6982AF26R000002
CA FLAP SCR T5(1A) Monterey Bay Sanctuary Scenic Trial
Question and Answers 5/06/2026
Page 1 of 8

Emergent Wetland? Is it the following Sheet 1 of 1?

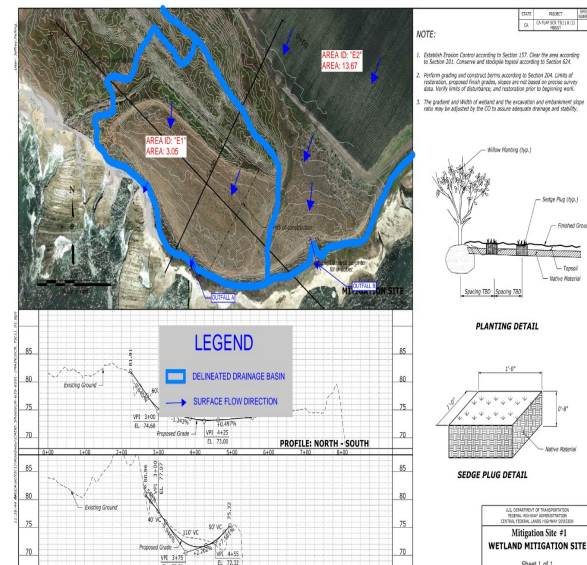
27. No browse cages or gopher cages are called out in the details, would you like these to be included?	Bid as shown.
28. Section 626.03 General specifies, "Layout plants randomly as shown in the plans to mimic a more natural distribution and to avoid grid patterns." Where is the Planting Detail sheet for the	Reference Plan Sheet T2 - Wetland Planting Detail and Randomized Planting Detail for layout. The Hydrologic and Hydraulic Technical Memorandum is a supplemental

report, refer to Plans and Specifications for planting requirements.
